# ENGINEERING CHANGE NOTICE DART AEROSPACE LTD

C3-C C3 CAGE

FW: ECN 19-814 (C3-C)

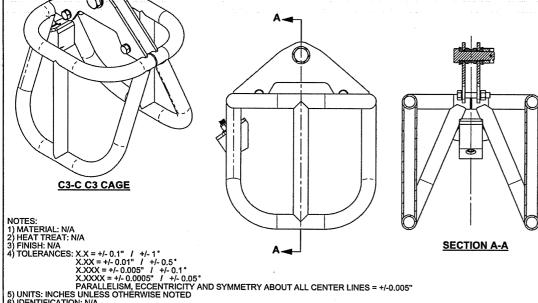
(19) 19) (-12)8 ITEM -10 McMaster#94191A350 CHANGED FOR McMaster#97135A235
ITEM 19 CTY OF 4X CHANGED FOR 5X
ITEM 20 ADDED
ITEM -6 DIMENSION Ø0.188 CHANGED FOR Ø0.191
ITEM -9 DIMENSION L J Ø0.625¥0.419 CHANGED FOR
LJ Ø0.672¥0.542, DIMENSION 1.63 ADDED, PIN CHANGED FOR
DOWLE PIN HOLE 19-764 vm FOR PREVIOUS REVS SEE OLD PDFs P/N ATTRIBUATED TO ALL McMaster# TO MATCH THE MANUAL G VM REV. DESCRIPTION -BK DESIGN DART AEROSPACE-LTD DRAWN VM HAWKESBURY, ONTARIO CANADA TOOL PART # CHECKED VM REV. H C3-C MFG. APPR. Wy SHEET 1 OF 10 TITLE APPROVED C3 CAGE

1- Scrap all C3-C-9 bumpers / we will make new C3-C-15 bumpers \_ AS ked Andrew

No the hardware need to be changed with aerospace hardware PER REV J Components <u>OTHER</u> than C3-C-9 & old hardware can be use as is.

8	7	, 6		5	4			
ITEM#	QTY	PART#		PART	TITLE				
-1	1	C3-C-1	î	WELDMENT	C3 CAGE				
-8	1	<del>  63</del> -€-8	4	LIFTING E	BUSHING				
-9	1	<u>C3-C-9</u> \ \ \ \ \ \ \ \ \ \ \ \ \ \ \ \ \ \ \	LV.	BUM	PER				
-10	2	C3-C-10	McMaster#97135A235 OR E	QUIV (ZINC YELLO	W PLATED GRADE 8	STEEL HEX NUT 3/8"-24)			
-11	1	C3-C-11	McMaster#90157A112 OR E	EQUIV (STEEL CAD	PLATED COTTER P	IN 1/8" DIA. X 1-1/4" LG.)			
-12	1	C3-C-12	McMaster#92562A358 OR EQI	JIV (CAD PLATED :	STEEL SOCKET HEA	D SCREW 3/8"-16 X 2" LG.)			
-13	1	C3-C-13	McMaster#98023A031 OR EQU	IIV. (YELLOW ZINC 0.812" OD. X 0.0	PLATED GRADE 8 S 51"-0.080" THK.)	STEEL WASHER 0.406" ID. X			
-14	1	C3-C-14	McMaster#97135A230 OR E	QUIV. (ZINC YELLO LOCKNU	OW PLATED GRADE T 3/8"-16)	8 STEEL NYLON INSERT			
15	2	AN6-17A	CAD P	LATE STEEL HEX E	BOLT 3/8"-24 X 1.953	LG.			
. 16	1	AN10-22	CAD PI	LATE STEEL HEX H	IEAD 5/8"-18 X 2.391	" LG.			
17	1	AN310-10	C.	AD PLATE STEEL (	CASTLE NUT 5/8"-18

18	2	NAS1149F1032P	STEEL V	WASHER 0.640" ID.	X 1.188 OD. X 0.065	" THK.			
19	5	NAS1149F0663P	STEEL V	VASHER 0.390" ID.	X 0.625" OD. X 0.063	"THK.			
20	1	McMaster#98380A504 OR EQUIV	S	S416 DOWEL PIN 3	/16" DIA. X 7/16" LG.

12) APPLY RETAINING COMPOUND LOCTITE 620 OR EQUIVALENT ON MATING SURFACES THEN PRESS FIT ITEM 20 WITH ITEM -9, AND REMOVE EXCESS
